Access Compliance Report

Public Rights-of-Way

(Curb Ramps)

Intersection ID: 45782	Main Street: BITTER_CREEK_DR	Cross Street: LONG_HILL_DR	Location: NE
ADA ID: 2B5EBB33D8D6	Ramp Type: PerpDiag	Initial Pass/Fail: Fail	Overall Compliance: No
Severity Score: 37.5			
Codes/Mitigation Info/Possible Solution		Field Measurements/Component Compliance

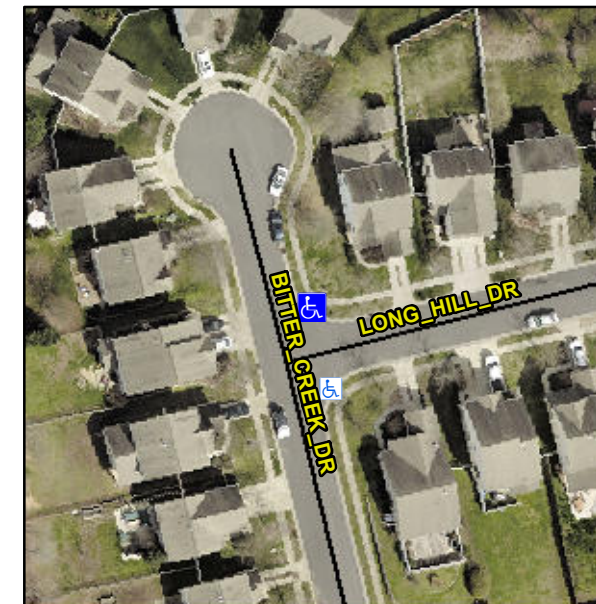
Not Found, R304.2.2, R304.5.3

Compliance	Description	Data	Compliance	Description	Data
N/A	Ramp Length (in)	61.0	No	Ramp Slope (%)	12.8
Yes	Ramp Width (in)	48.0	No	Ramp XSlope (%)	6.0
N/A	Flare Type LT	N/A	N/A	Flare Type RT	N/A
N/A	Flare Slope LT (%)	N/A	N/A	Flare Slope RT (%)	N/A
N/A	Flare Traversable LT?	N/A	N/A	Flare Traversable RT?	N/A
N/A	Landing Length (in)	N/A	N/A	DWS Provided?	N/A
N/A	Landing Width (in)	N/A	N/A	DWS Contrast?	N/A
N/A	Landing Slope (%)	N/A	N/A	DWS Length (in)	N/A
N/A	Landing X Slope (%)	N/A	N/A	DWS Full Width?	N/A
N/A	Landing Curb? (Y/N)	N/A	N/A	DWS Offset (in)	N/A
N/A	Shared Landing?	N/A			
N/A	Gutter Ponding?	N/A	N/A	Gutter Slope (%)	N/A
N/A	Gutter Lip Ht (in)	N/A	N/A	Gutter X Slope (%)	N/A
N/A	Painted X Walk1?	No	N/A	Painted X Walk2?	No
	X Walk 1 Direction	To W		X Walk 2 Direction	To S
N/A	X Walk 1 Width (in)	N/A	N/A	X Walk 2 Width (in)	N/A
	X Walk 1 Slope (%)	4.7		X Walk 2 Slope (%)	1.2
	X Walk 1 X Slope (%)	3.7		X Walk 2 X Slope (%)	1.8

Remove & Replace Curb Ramp With Two New Directional Ramps or Equivalent.
